Transmitted by the expert from the European Commission Informal document **GRSP-56-XX**

**Proposal for Amendment [x] to global technical regulation  
No. 9 (Pedestrian safety)**

**Proposal for further amendments to document  
GRSP-54-33, submitted by the informal working group on global  
technical regulation No. 9**

Figure 5A: Corner of bumper (see paragraph 3.13.)

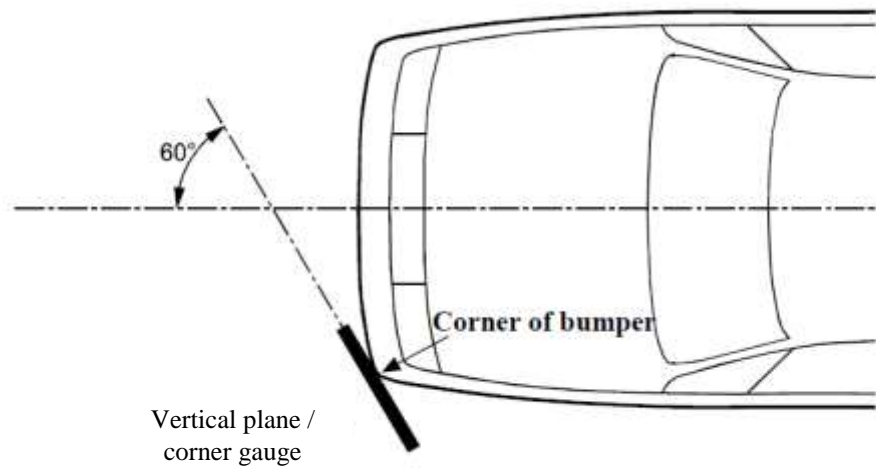
Paragraph 3.13. amend to read:

- 3.13. **"Corner of bumper"** means **the transversal position** of the vehicle's point of contact with a vertical plane ~~which makes an angle of 60° with the vertical longitudinal plane of the car and is tangential to the outer surface of the bumper (see Figure 5).~~ **corner gauge as defined in Figure 5B.**

**For determination of the corner of bumper, the front surface of the corner gauge is moved parallel to a vertical plane with an angle of 60° to the vertical longitudinal centre plane of the vehicle (see Figures 5A and 5C) at all heights of the centre point of the corner gauge in the following area:**

- a. Equal or above a point found in vertical direction on the Lower Bumper Reference Line at the assessment position in transversal direction or at 75 mm above the ground reference plane, whichever is higher.**
- b. Equal or below to a point found in vertical direction on the Upper Bumper Reference Line at the assessment position in transversal direction or at 1003 mm above the ground reference plane, whichever is lower.**

**For determination of the corner of bumper the gauge is moved to contact the outer contour of the vehicle touching at the vertical centreline of the gauge .**

**The corner of bumper is then defined as the outermost point of contact of the gauge with the outer contour of the vehicle according to this procedure.**

Figure 5B: Corner Gauge

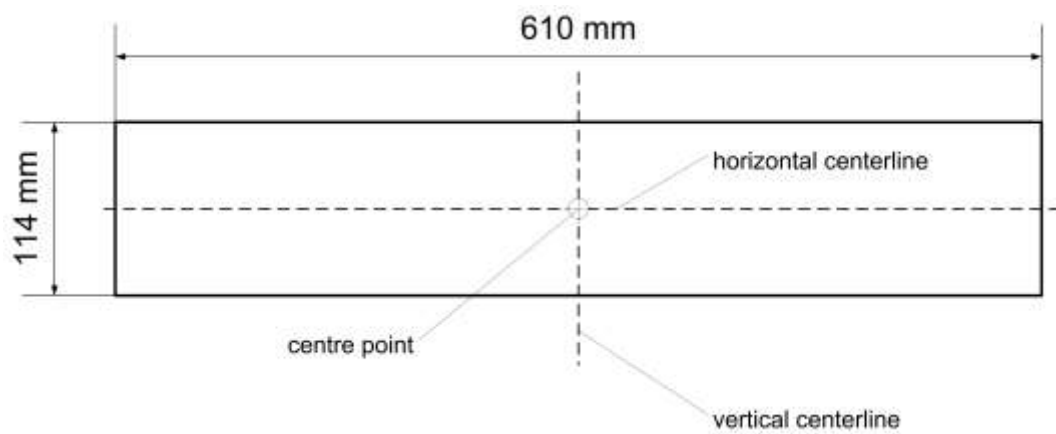
**The front surface of the corner gauge is flat.  
The centre point is the intersection of the vertical and horizontal centreline on the front surface.**
